1990 Corvette: Service Bulletin: Information on Door Lock System Components and Replacement Components

Subject: INFORMATION ON DOOR LOCK SYSTEM COMPONENTS AND REPLACEMENT COMPONENTS

Model and Year: 1990 CORVETTE

Bulletin Number: 90-375-10 - (10/25/1990)

Figure 1

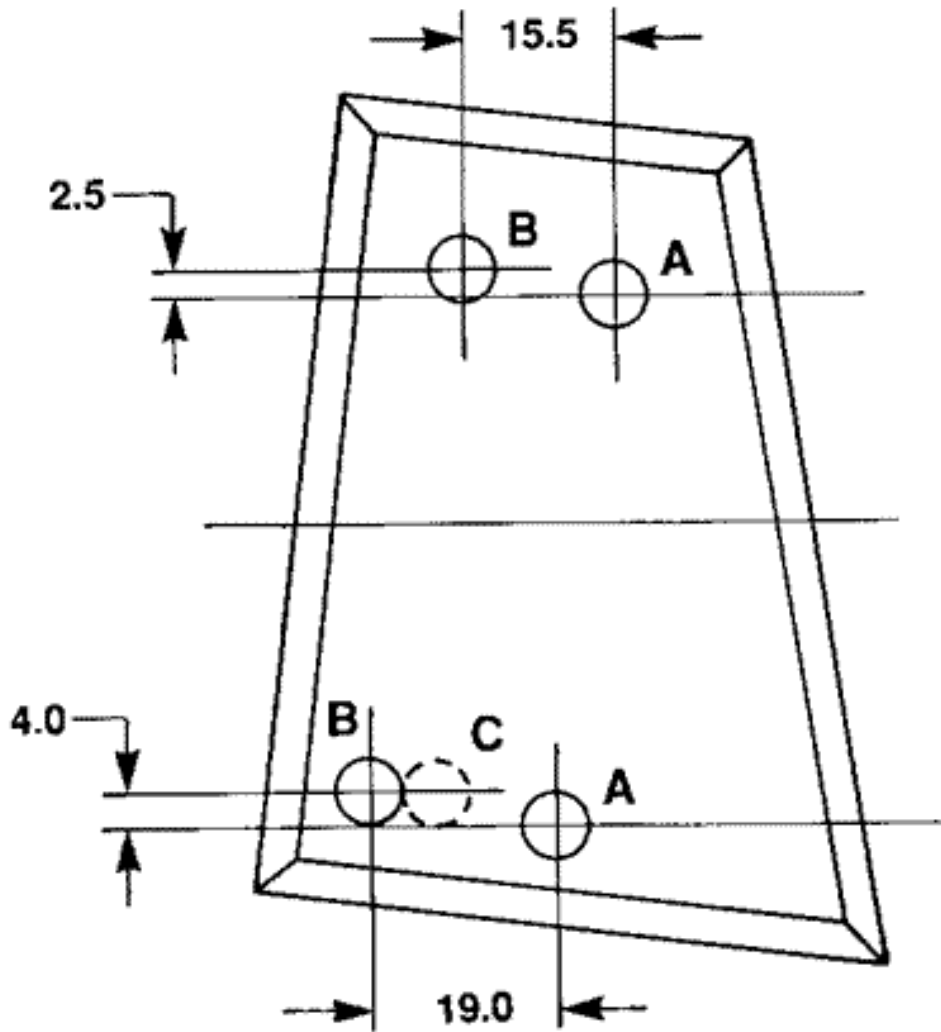
In addition to replacing the above components, it may be necessary to relocate the power door lock actuator on the door inner panel. Figure 1 will illustrate the hole patterns.

- If the actuator is located in the holes marked "A," it will not need to be relocated.

- If the actuator is located in the holes marked "B";
- remove the actuator by drilling out the attaching rivets.
- locate the new attaching holes ("A") using the dimensions on the illustration.
- attach the actuator in the new location using 1/4" X 1/2" peel type rivets.

IMPORTANT: Hole "C" may or may not be present. Relocate holes from "B" locations only.
